ADDENDUM #1 TO THE TECHNICAL DRAINAGE STUDY FOR MOCCASIN HOMESTEAD WEST

CENTURY
COMMUNITIES

STRIVE
ENGINEERING

March 15, 2022

Cross Section for SECTION C - Q100 TRAILS END FULL-STREET PROPOSED

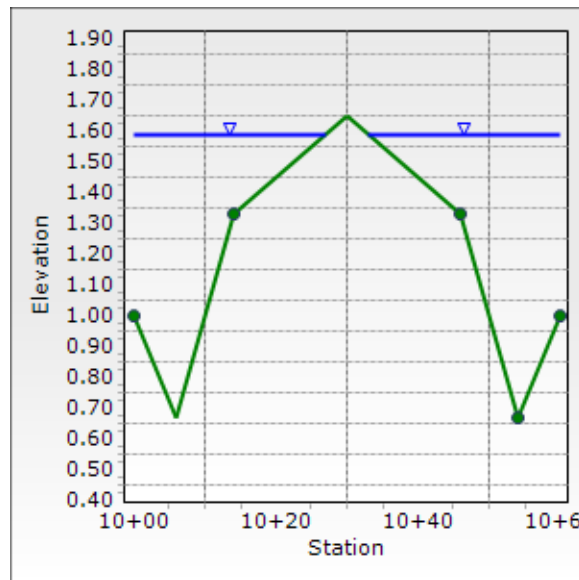
- Response: The flow rate summary table has been revised to match the HEC-1 model output.
- Comment 8:** **Cross section C – Q100 Trails End Full-Street Proposed cross section flowmaster was analyzed at 122 cfs. Per CP-D and the summary table, it should be analyzed at 124 cfs which is also inconsistent with the Proposed Condition Flow Rate Summary Table on the exhibit.**

- Response: Cross section C has been revised to model the corrected Q100 flowrate of 127 cfs. The increase of 3 cfs is due revising the HEC-1 model with the correct intensity of 2.77 inches for the 100-year storm event. Please note that cross section C was not analyzed using concentration point, CP-D, because runoff from street basin HOM-S does not flow through cross section C.

Cross Section for SECTION G - Q100 16"X48" WALL OPENING 50% CLOG

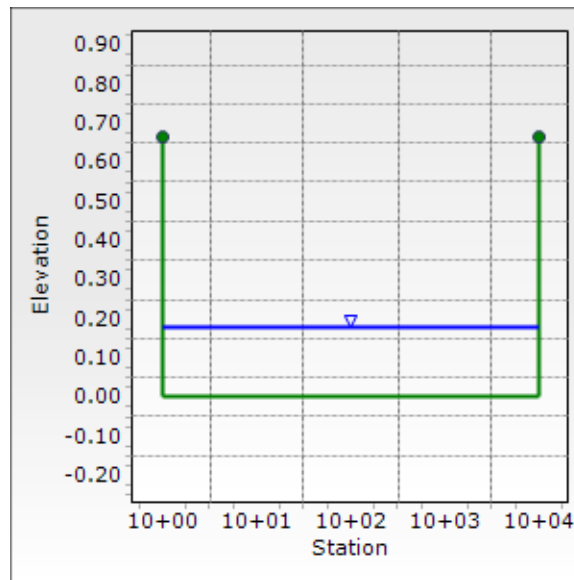
Comment 20: Block wall openings must be 16” x 48”. The detail on DT-02 BLOCK WALL OPENING needs to designate this size.

Response: The dimension callout of 16”x48” has been added to the block wall opening detail.

Cross Section for SECTION J - Q100 SOUTHWEST BNDY GRADED SWALE

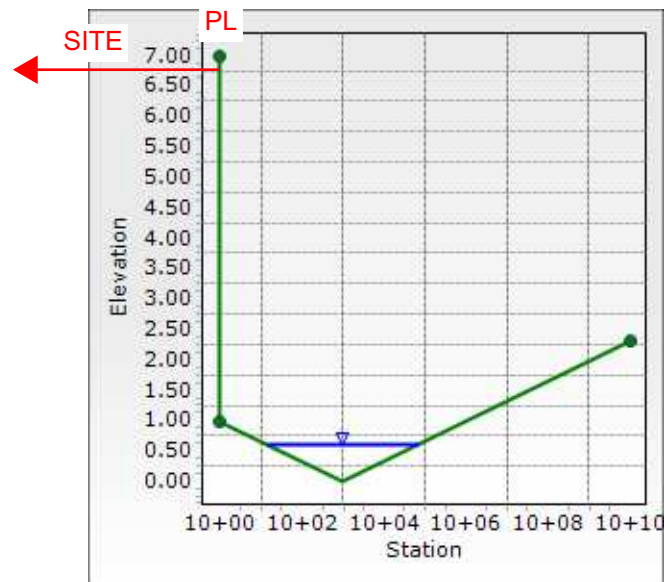
Comment 17: Cross Section J/DT-01 shown along the north of Lot 7 does not match the Detail J provided on Sheet DT-01.

Response: Cross section J has been revised to reflect the current grading, please see **Appendix D** for the revised plans.

03/14/22
PR-01
1 OF 1
DRAWING NO.
TBD

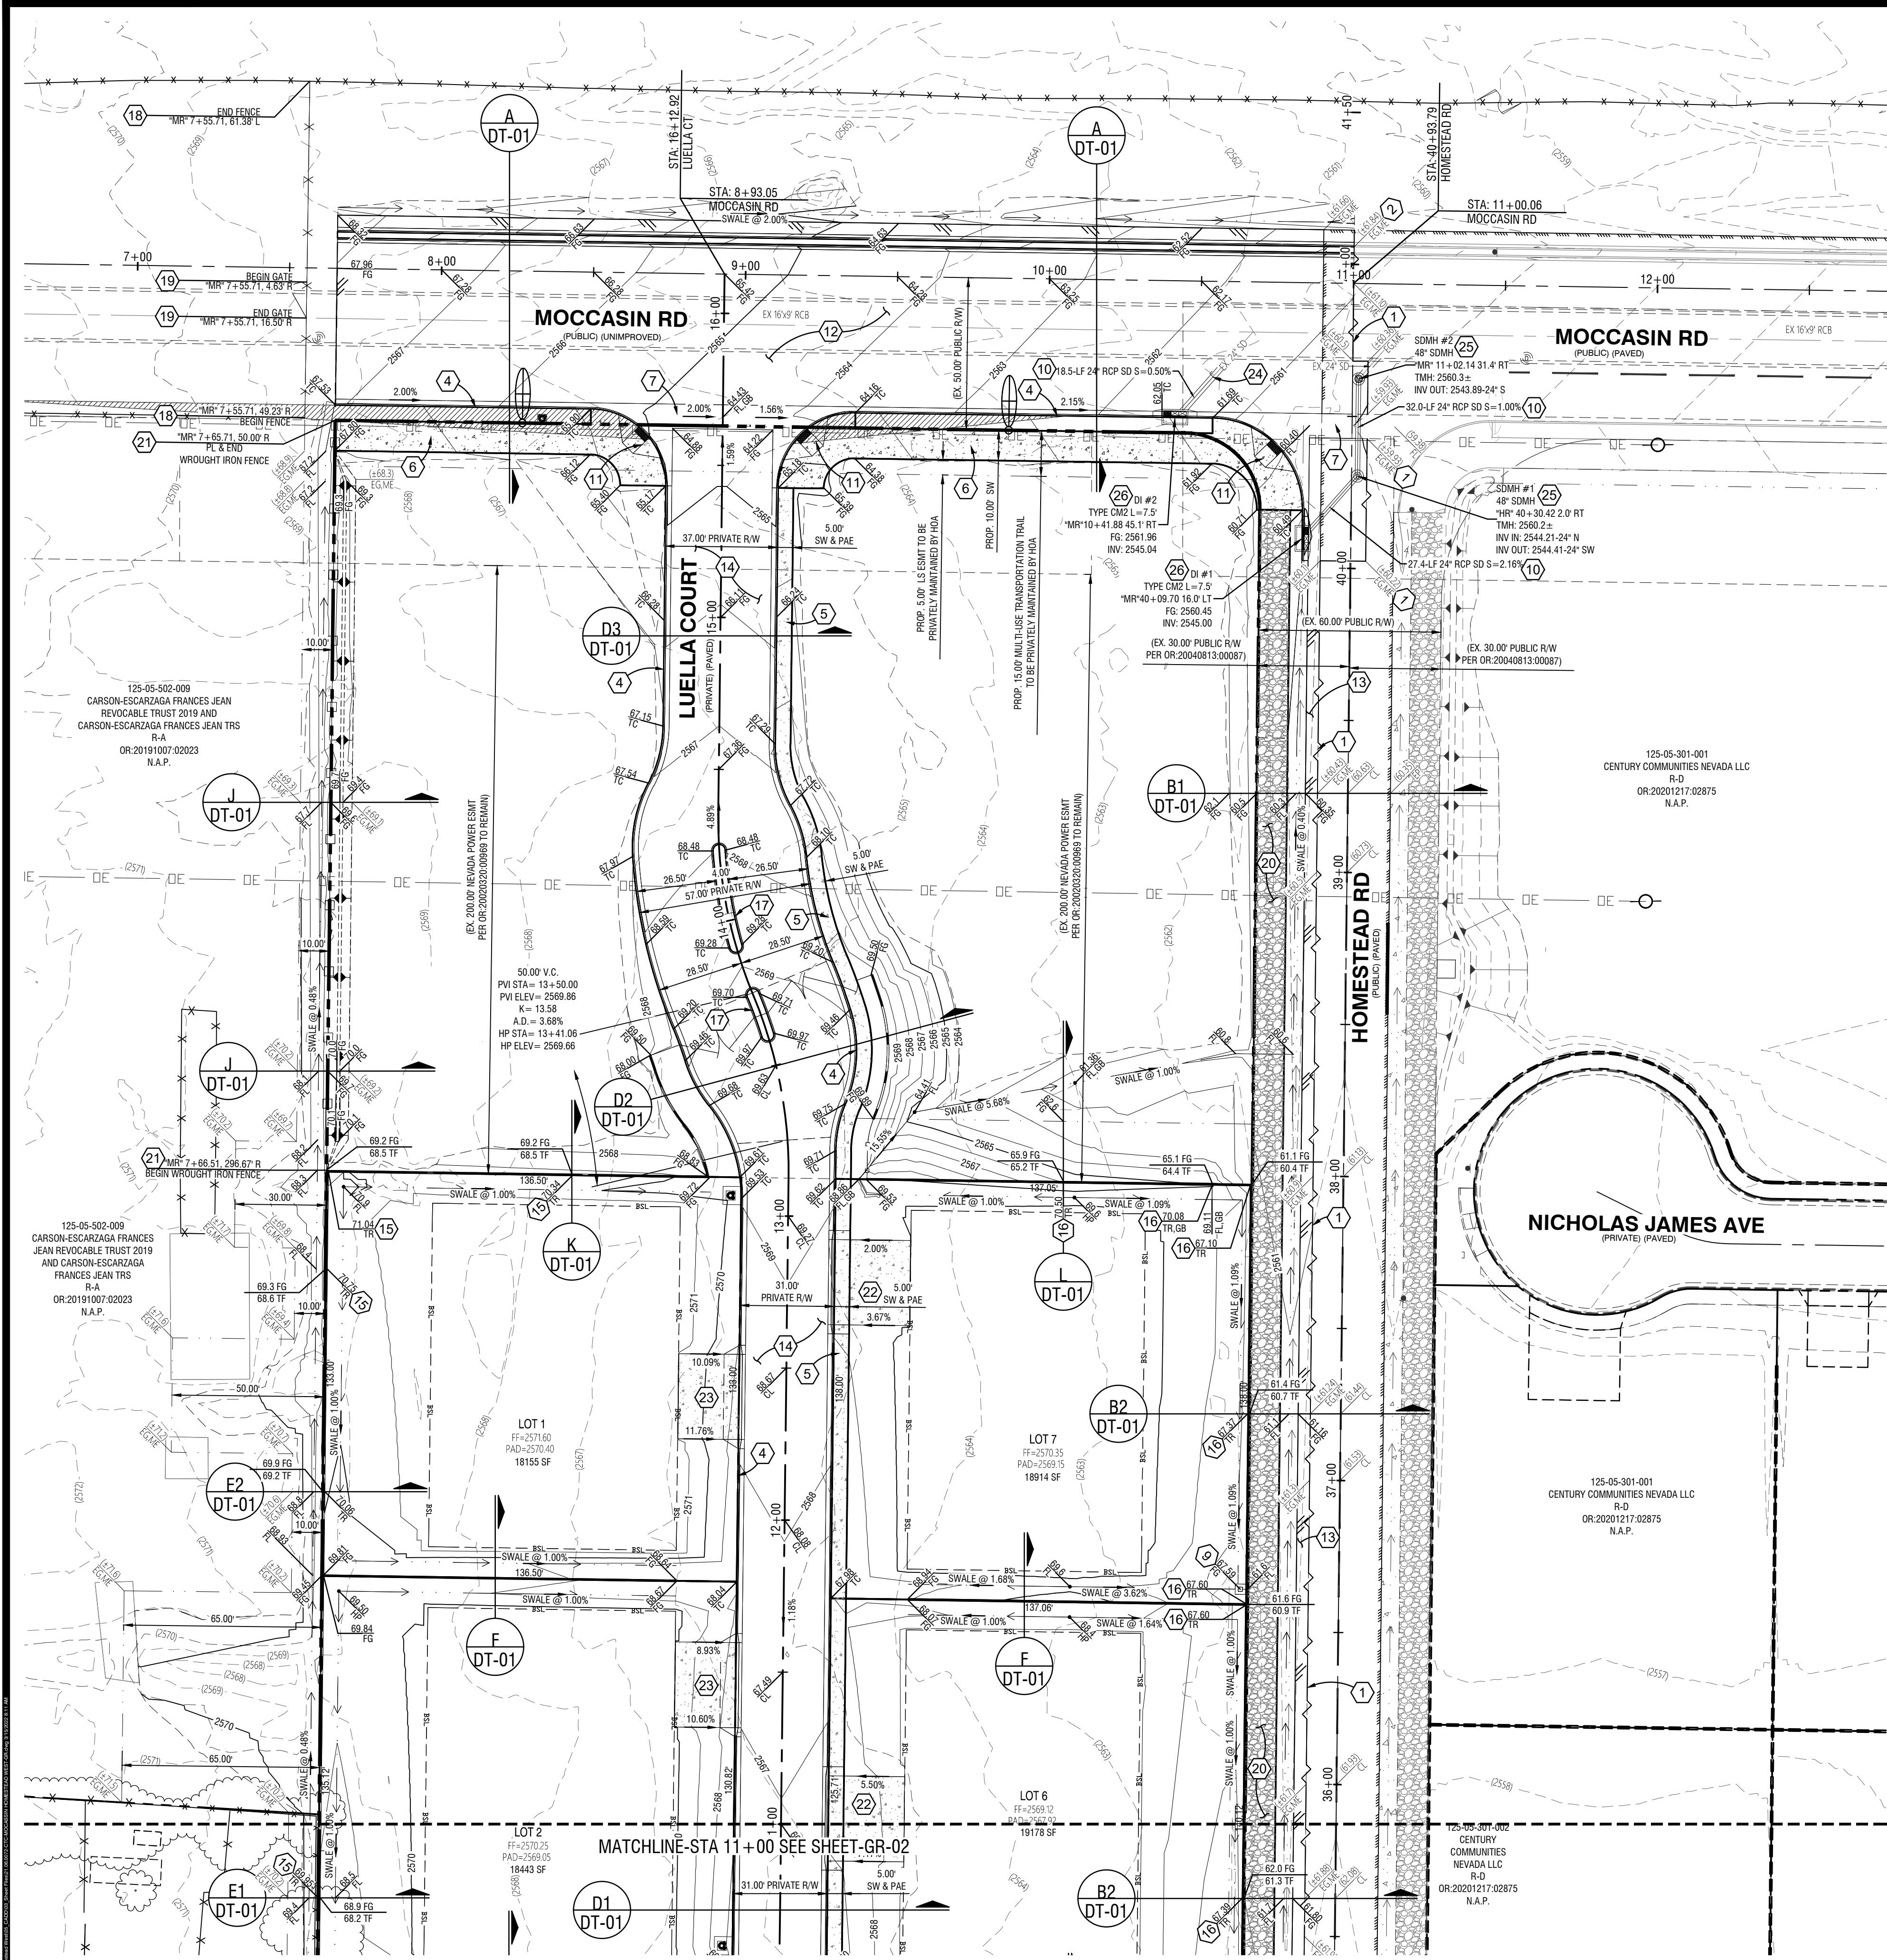
- Comment 5:** **Proposed Condition Drainage Map PR-01: Tables should state the studies that flows are referenced from.**
- Response: The reference studies have been added to the summary tables for clarity and a revised proposed condition basin map is included in **Appendix D**.

- Comment 6:** **Proposed Condition Drainage Map PR-01: Per the reference material, the CP-A should be 3/28. However, the basin map says 3/27. Clarify discrepancies.**

- Comment 7:** **Proposed Condition Drainage Map PR-01: Basin map proposed condition summary map is inconsistent with HEC-1. For example, basin MOC flows on summary table are 1/1 and in the HEC-1 they are calculated at 1/<1. For HOM-N the summary tables list <1/<1 and in the HEC-1 they are calculated at 1/<1.**

- Response: As discussed in the previous submittal, concentration point CPA is derived from adding reference basins, CP2 and EMR1, and then subtracting prorated basin ANW130-W(A) from the sum. This results in 3/27 CFS instead of 3/28 CFS. The annotated reference basin map, **Figure EX-01 "Existing Condition Offsite Drainage Basin Map"** has been included again in **Appendix A** for your reference.

SHEET
GRADING PLAN 1

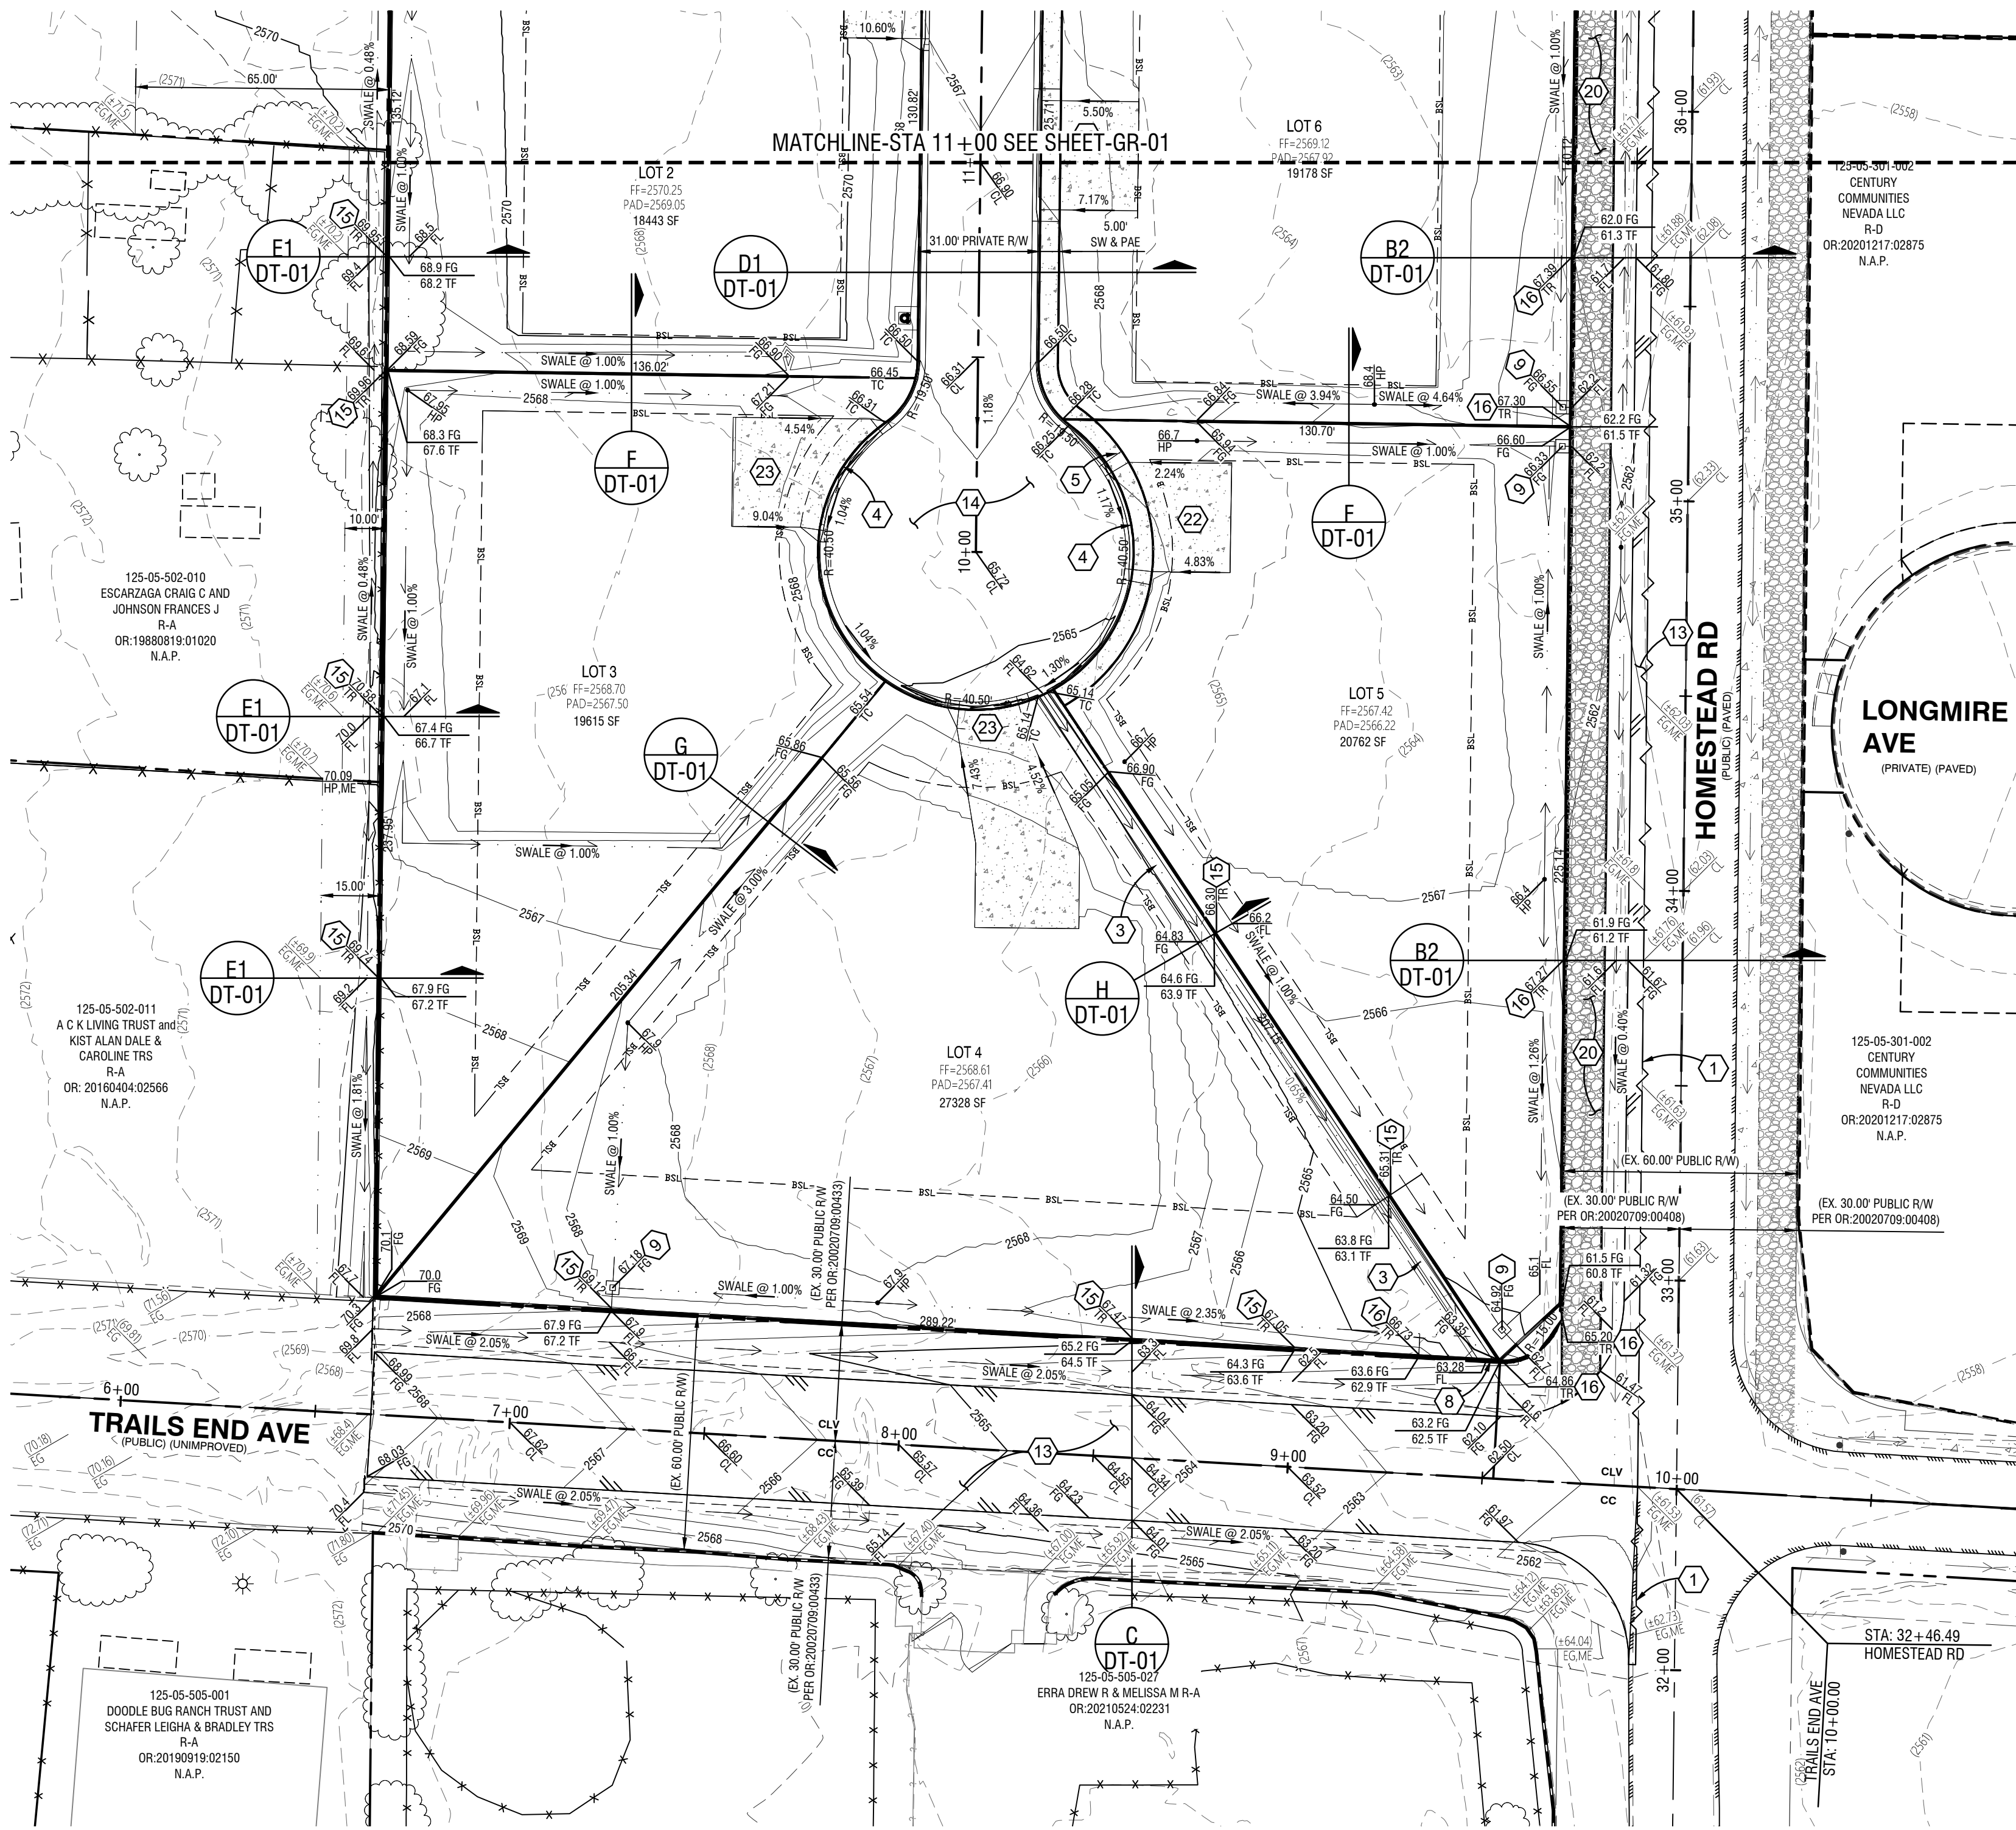
- Comment 9:** **GR-01: Properly fill out the Flood Zone Information.**
- Response: The flood zone information has been fully populated on the revised plans, which are included in **Appendix D**.

- Comment 10:** **GR-01: Detail Section A/DT-01 shows a 5'-landscape easement behind the 10'-wide Multi-Use Trail, however, the plan view does not reflect such a landscape area. Review and revise accordingly.**

- Response: A dimension call out has been provided on the grading plans to denote the 5' landscape easement for clarity.
- Comment 11:** **GR-01: Provide construction note for the proposed drop inlet in Moccasin Road. Provide plan & profile for the street and inlet.**

Response: Constructions notes for the proposed drop inlet and storm drain system has been added to the grading plans and separate plan and profile sheet have been cut for the storm drain laterals.
